**WHITEMARSH TOWNSHIP PLANNING COMMISSION
MEETING OF FEBRUARY 11, 2020 7:00 PM**

- Review (continued) SLD #05-14; 901 Washington Partners, LP/901 Washington Street
Revised Preliminary Plan; 62 Townhomes

TO: PLANNING COMMISSION
FROM: **Charles L. Guttenplan, AICP, Director of Planning and Zoning**
SUBJECT: MATERIAL FOR FEBRUARY 11, 2020 MEETING
DATE: FEBRUARY 7, 2020
CC: Vincent Manuele, BOS Liaison
Richard L. Mellor, Jr., Township Manager
James Hersh, PE, Township Engineer
Dave Sander, Esq., Township Solicitor

The second agenda item is a continued review of SLD #05-14, Revised Preliminary Land Development Plans for 901 Washington Partners, LP for their 62-unit townhome development. These plans have been revised since the January 14, 2020 Planning Commission meeting at which these plans were first presented. You will recall from the January 14th meeting that the proposal is for 62 units, 46 stacked/front to back units, and 16 traditional townhouses; the revised plans show the same breakdown. In addition to updates to the plan sheets provided for that meeting, two new plan sheets (#'s 20 and 21), are enclosed. Also included: the applicant's response letter to my zoning review and

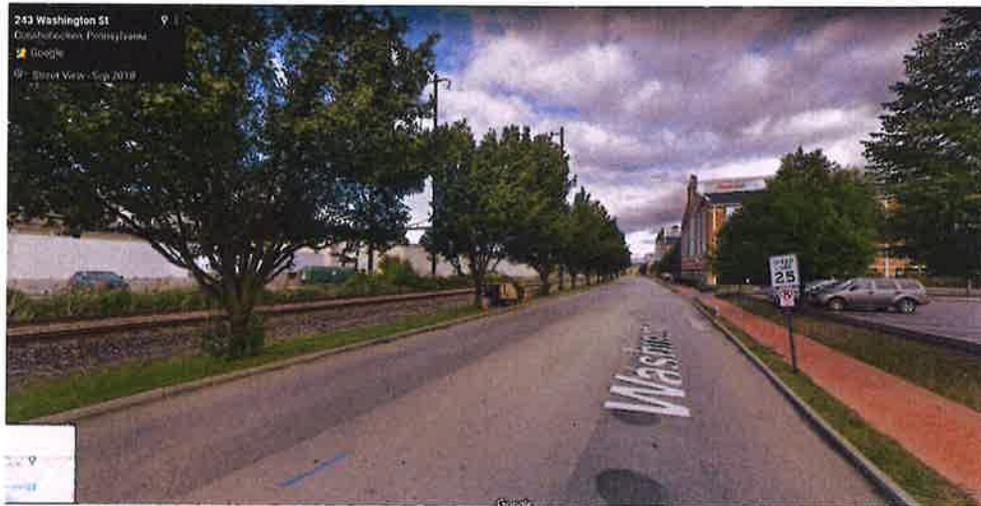
a. Riverfront Development District Requirement for Perpendicular Access Paths - The plan does not fully address the conditions of the Zoning Heard Board decision of February 25, 2019 for riverfront access (Condition #6) and the requirements of Section 105-47.K.(2)-(6) which require a perpendicular access point and pathway. It appears given the wide street frontage of the tract, over +/- 550 feet of street frontage, two access points and public walkways are required for the riverfront. The required public sidewalk to the riverfront pathway is not shown on south-eastern side of the development (next to David's Bridal property). The township should ensure that the plan addresses Section 105-47.K.(2)-(6), with the provision of two perpendicular access points and pathways, separated from vehicular traffic with appropriate directional signage for the public. The access pathways are required to each have one seating area and pedestrian lighting fixtures along the path.

b. Viewing Area - A public pathway with viewing observation points along the applicant's more +/- 650 foot-wide of riverfront area will become an important public asset for the township and townhouse residents. The western-most scenic overlook adjacent to the boat ramp is set back over +/- 100 feet from the riverbank and may be a less desirable scenic location than closer to the riverfront. The location of the viewing observation area should be located at an effective viewing point. We recommend the township assess the arrangement of this viewing area and consider moving it closer to the riverbank in order to maximize views along the riverfront. The plan does not include the required pedestrian benches, trash receptacles and pedestrian scale lighting as required by the RRD-Riverfront Development Overlay.

c. Boat Ramp - We suggest that in addition to the 'emergency boat ramp' the township consider a kayak/canoe launch, which is a viable recreational amenity. The previous sketch plan showed a 100-foot long asphalt ramp connected to 'Cast-in Place Boat Ramp'. The level of detail for what exactly is planned for this space is missing from the submitted plan. We encourage the township to assess the viability of a non-motorized kayak launch in addition to the emergency boat launch area which is a riverfront plan recommendation.

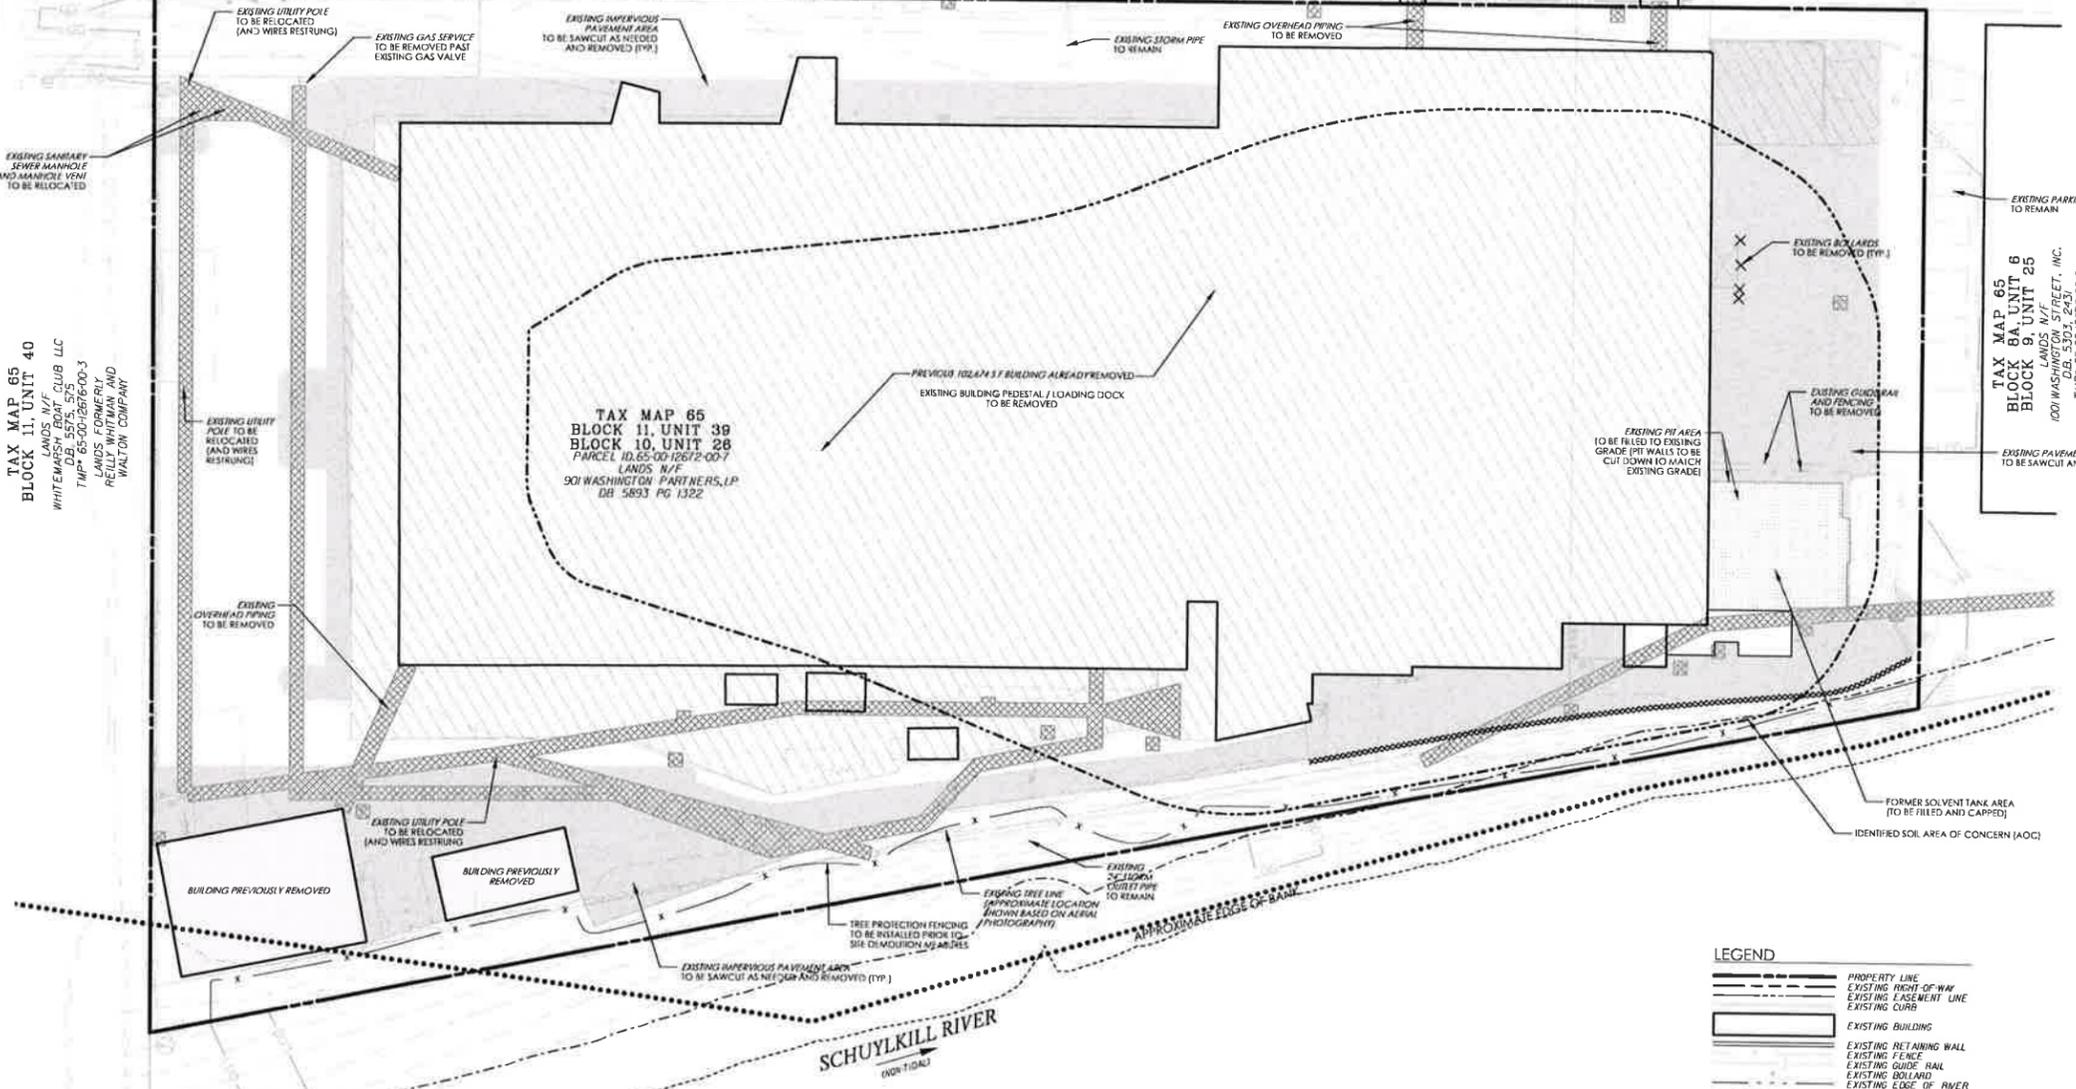
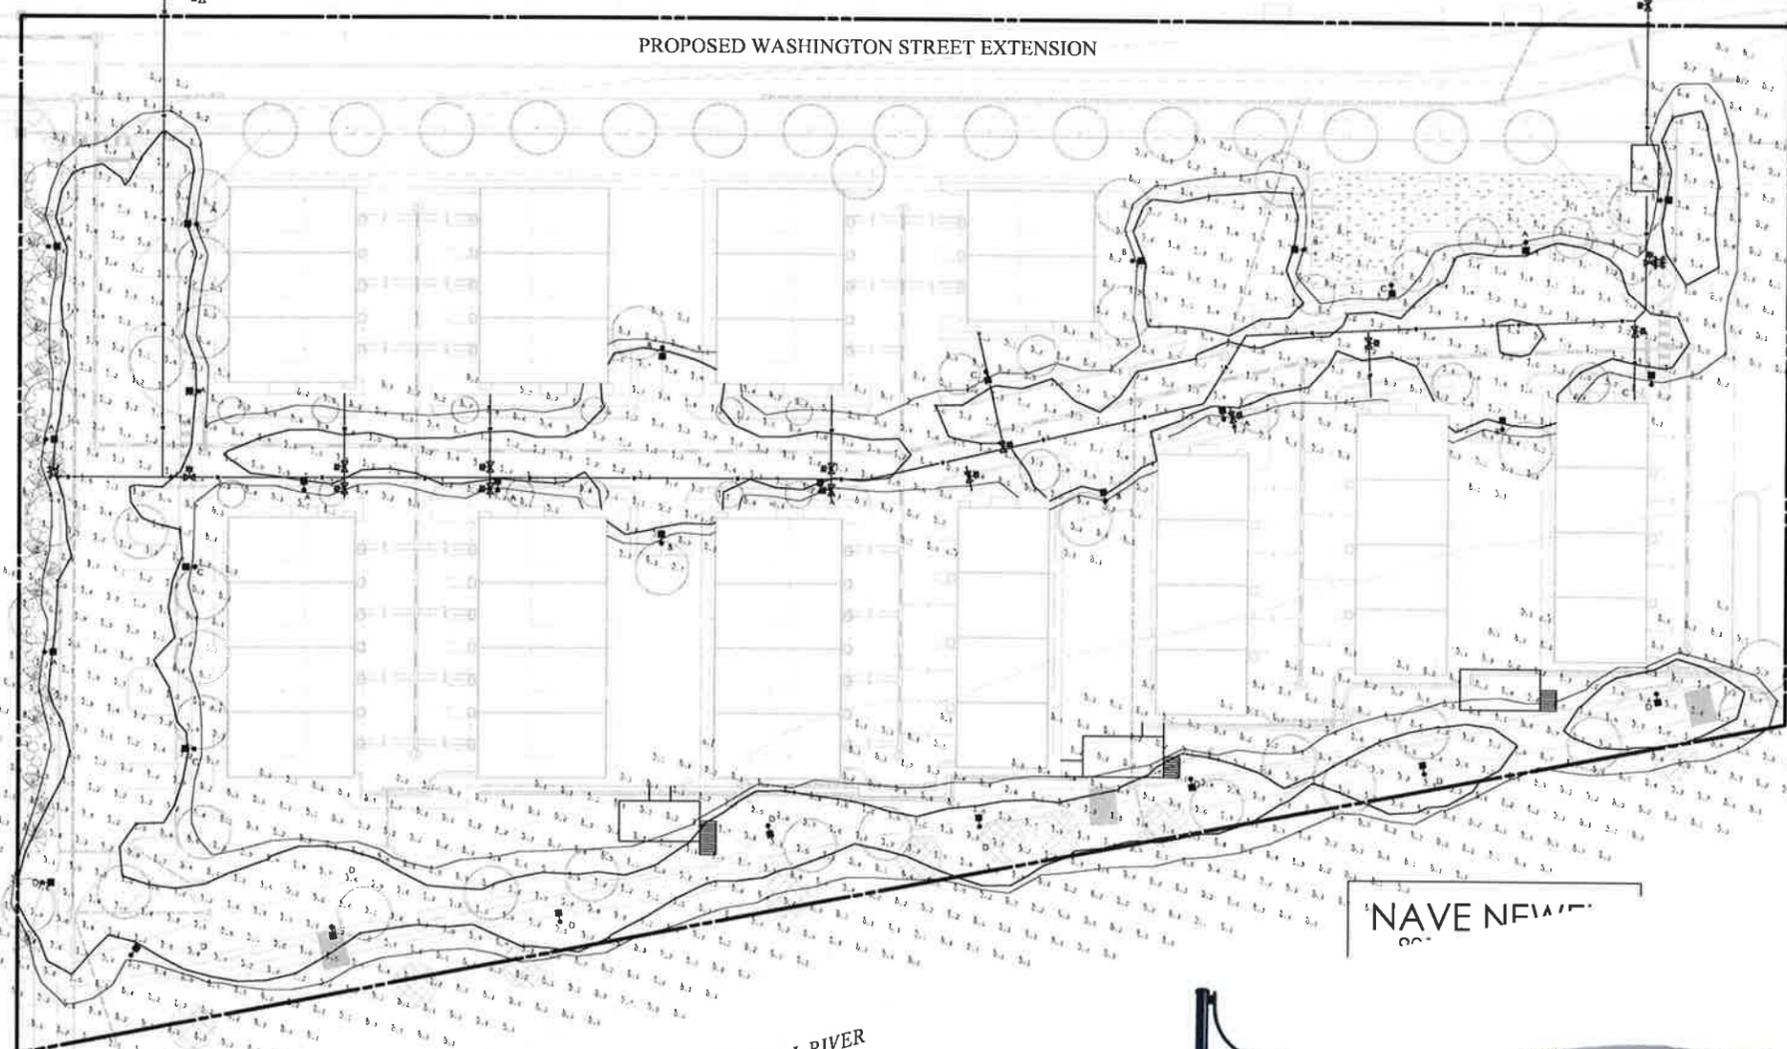
10. 105-21(B)(1)(e)[5] The plans must be revised to list the dwelling unit mix, if known.
Response: We have revised the Site Plan (Sheet 4) to show the front/back units and the single townhouses. We have also added a Townhomes Legend to this sheet.

11. 105-21(B)(1)(e)[6] The plans must be revised to list the size of units, in bedrooms, if known.
Response: We have added a Townhomes Legend the Site Plan (Sheet 4) that shows the size of the units and number of bedrooms.

Response: We have added 50' Clear Sight Triangle to the Site Plan (Sheet 4).
3. §116-28.A.(2) The applicant shall furnish a letter from the appropriate authority indicating the availability and supply of water for the proposed project to the Zoning Officer.

Response: We have added General Note 17 to the Site Plan (Sheet 4). We added the 50' Clear Sight Triangles to the Site Plan (Sheet 4).

Response: We have added the widths (25') of Driveways A, B, and C to the Site Plan (Sheet 4).
